FINAL
YEAR 6 (2021) ANNUAL
MONITORING REPORT

**NEIGHBORS BRANCH/WALTON CRAWLEY BRANCH
STREAM & WETLAND RESTORATION SITE**

RE: Neighbors Branch/Walton Crawley Branch Monitoring (DMS Project # 92872, Contract # D09023S)
Final Year 6 (2021) Annual Monitoring Report

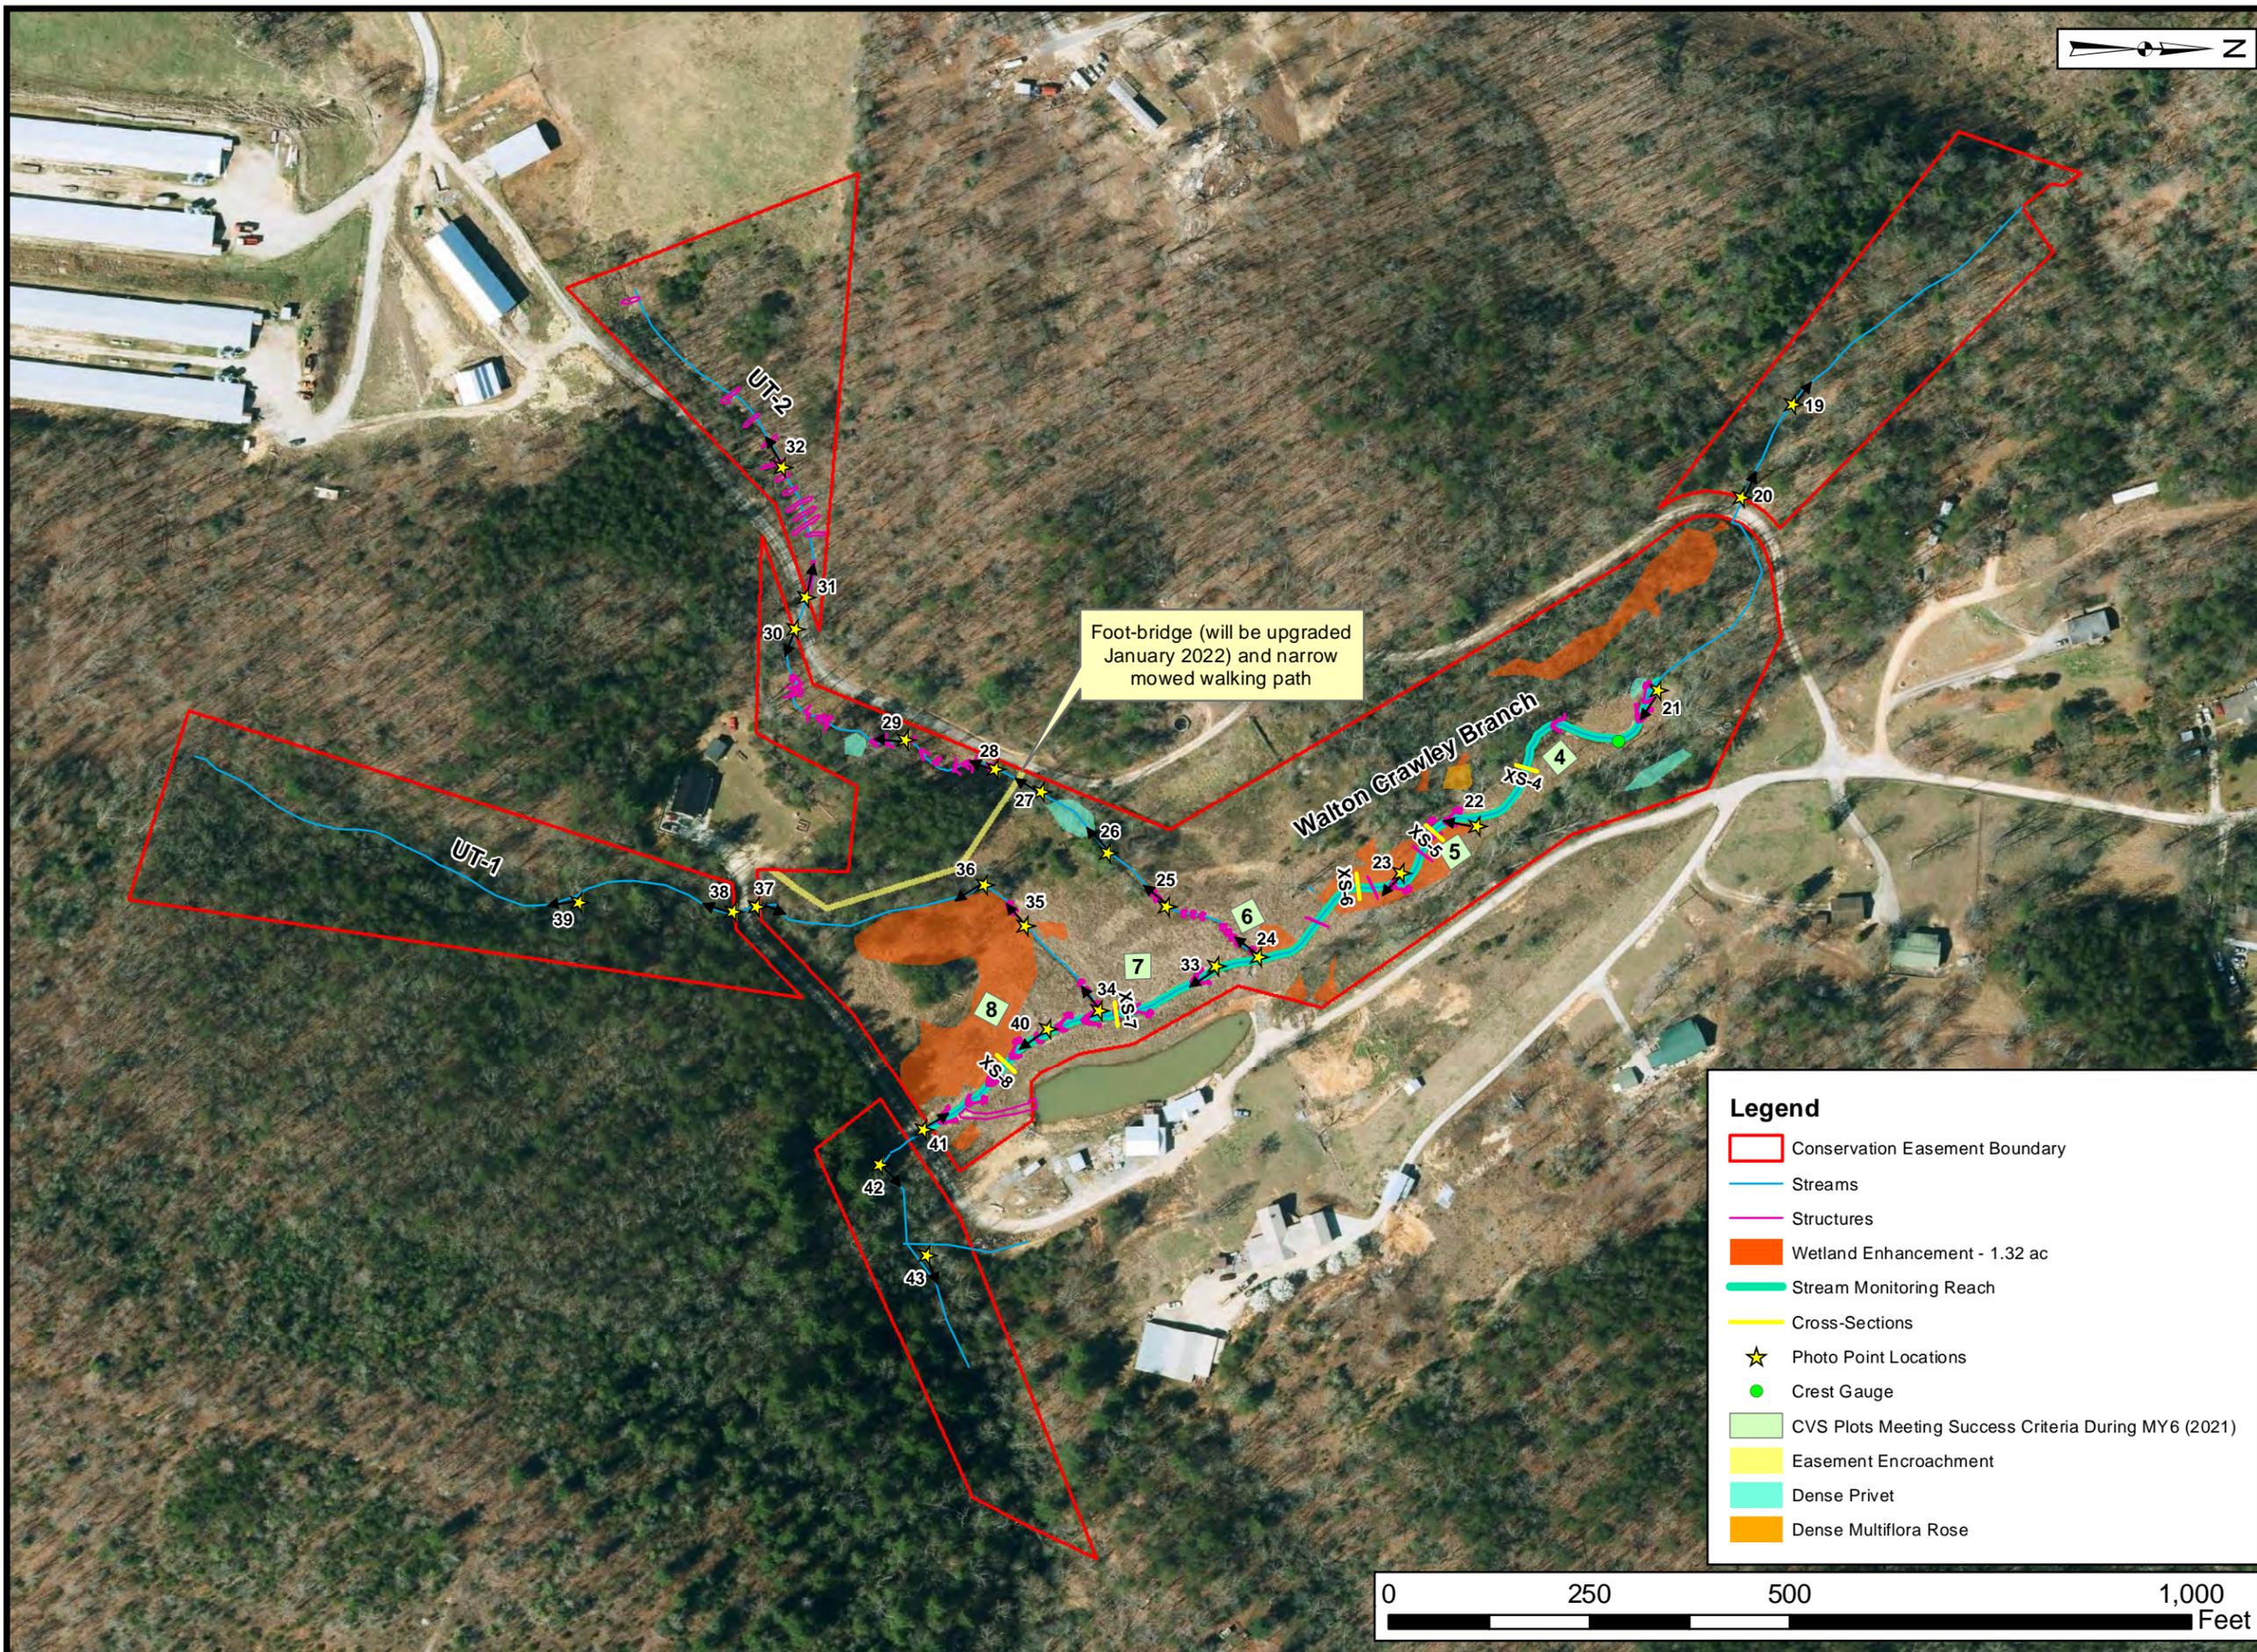
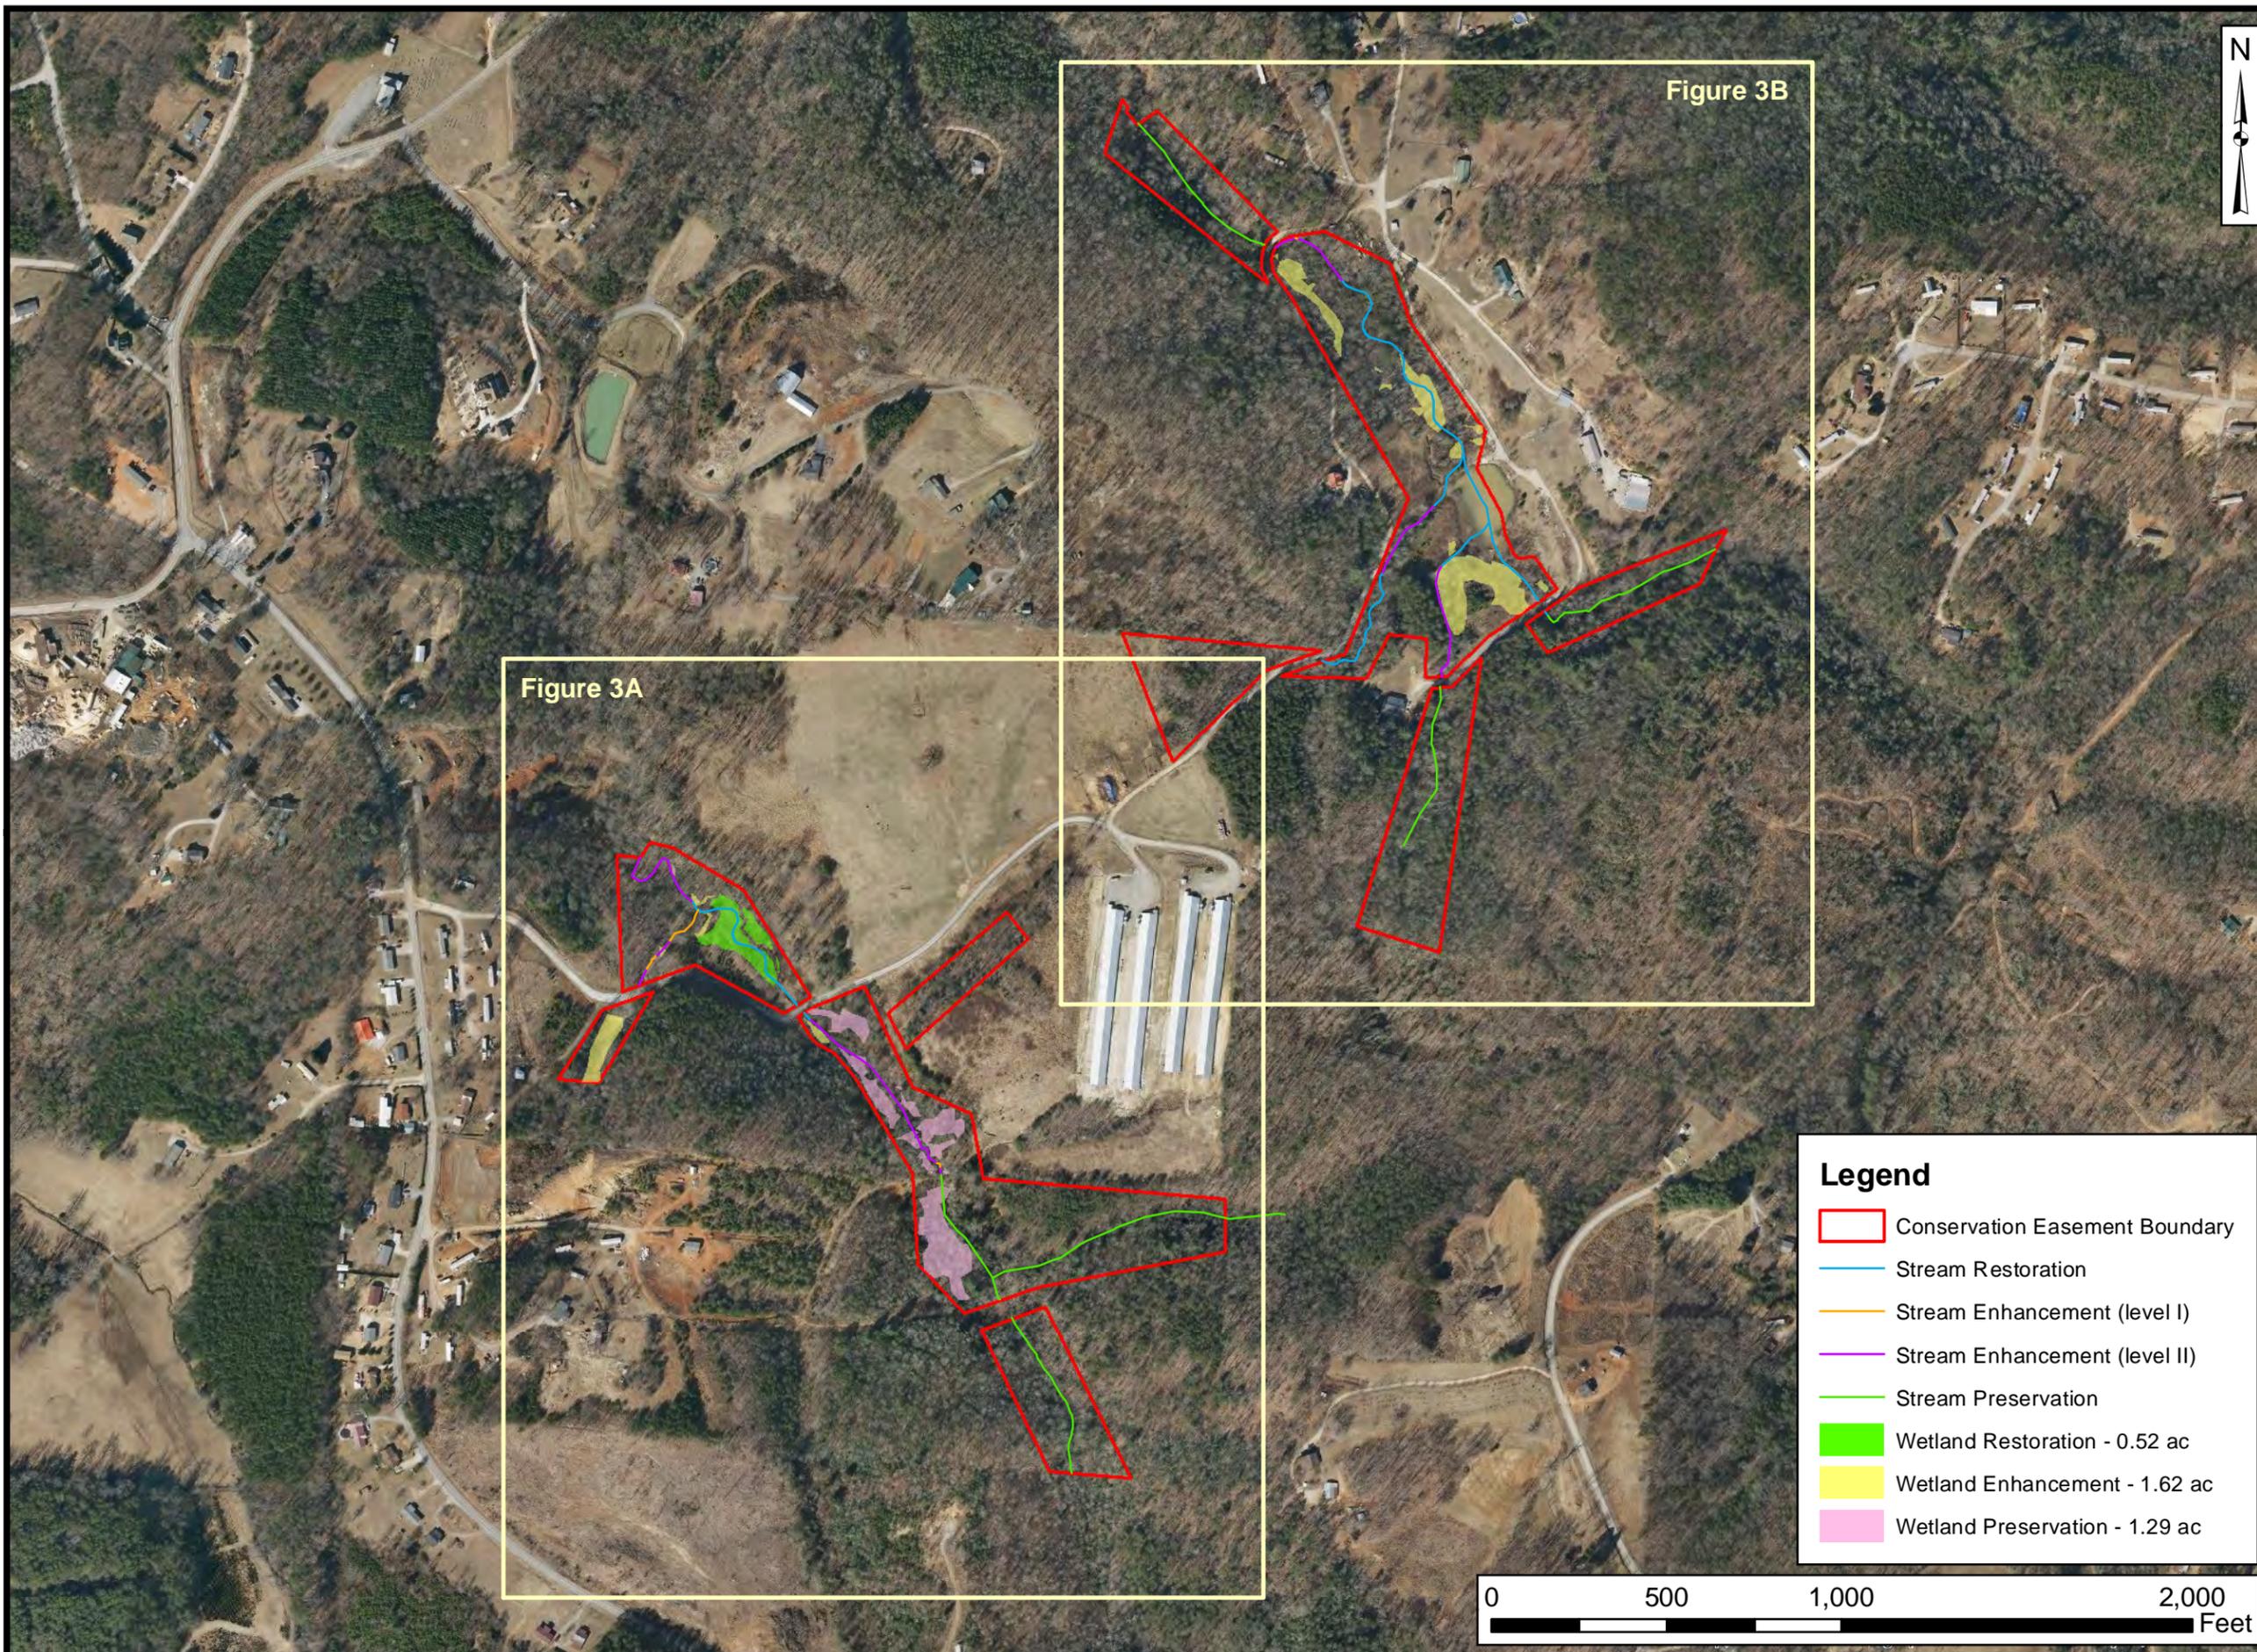
- CCPV: Thank you for providing updated invasive polygons on the CCPV. DMS will direct the invasive contractor to these areas before the project closes out.
Axiom is happy to help.
